### **REMARKS/ARGUMENTS**

**Amendments to the Drawings:**

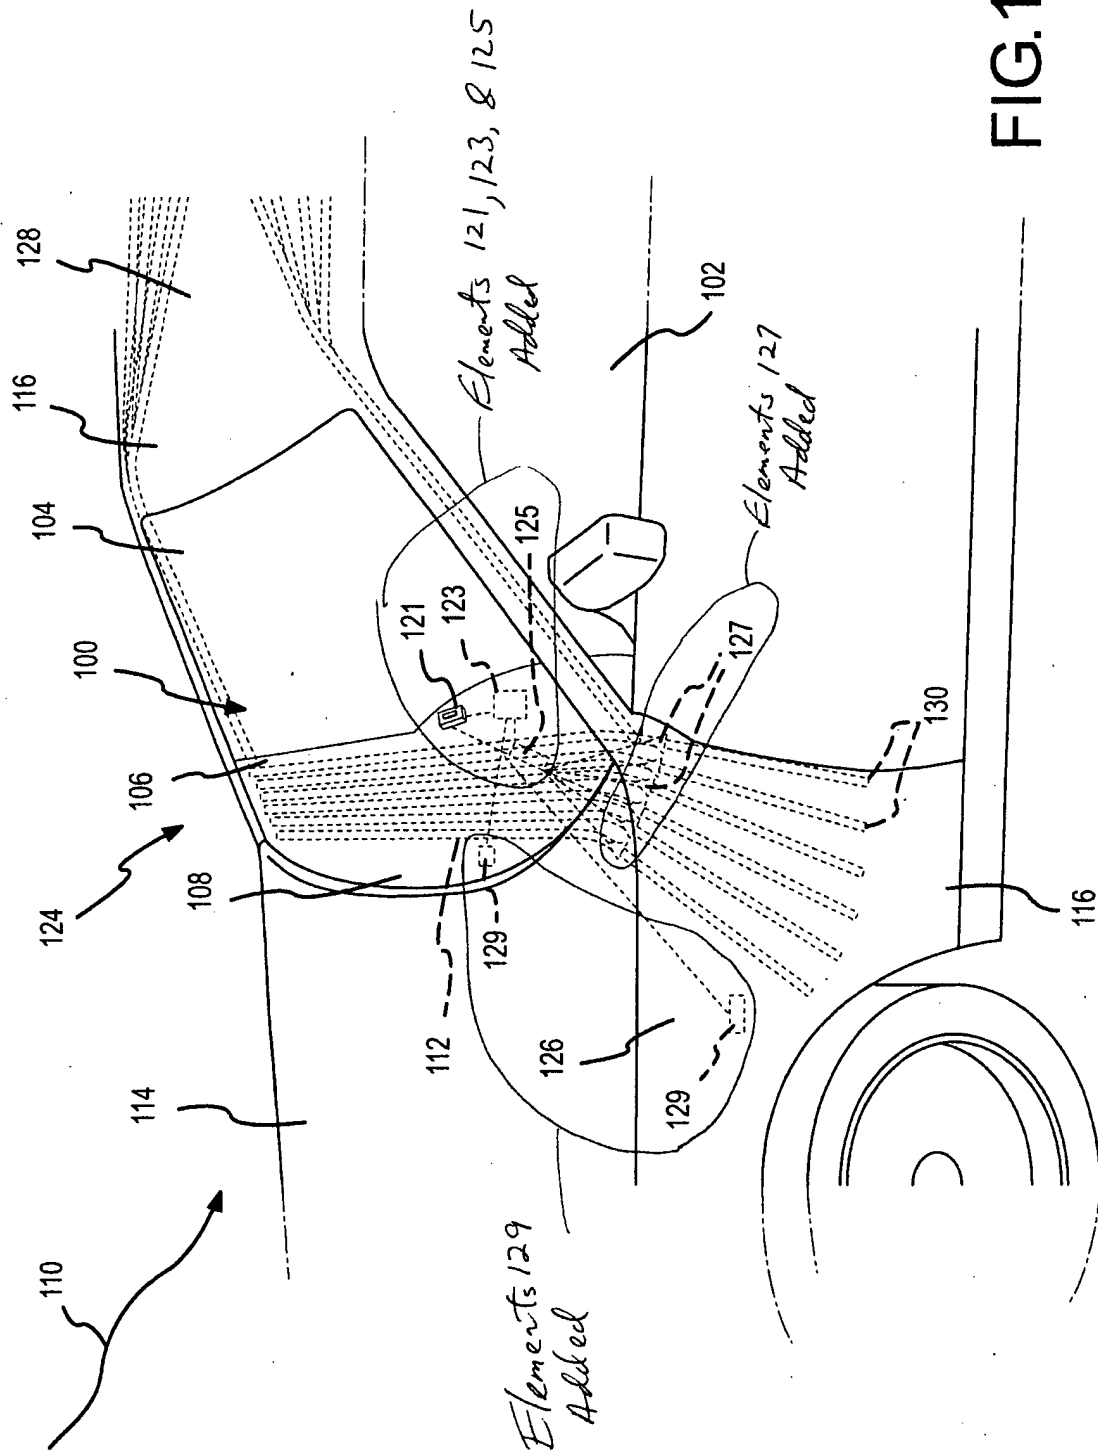
In the September 9, 2004 Office Action, the drawings were objected to for failing to show features of the invention specified in the claims including "the valve and sensors or triggers to [the] operate the valve."

Figures 1 and 3 were amended to show previously omitted features, with support found at least in the originally filed claims and corresponding portions of Applicant's specification, which has also been amended to include figure numbers for the originally described elements. No new matter is added by the drawing amendments.

The attached sheets of drawings include changes to Figures 1 and 3. These sheets, which include Figures 1 and 3, replace the original sheets including Figures 1 and 3. In Figure 1, the previously omitted manual switch 121, microprocessor/controller 123, valve trigger/controller 125, valves 127, and temperature sensors 129 have been added. In Figure 3, the missing element number "140" and the omitted brackets 113 were added.
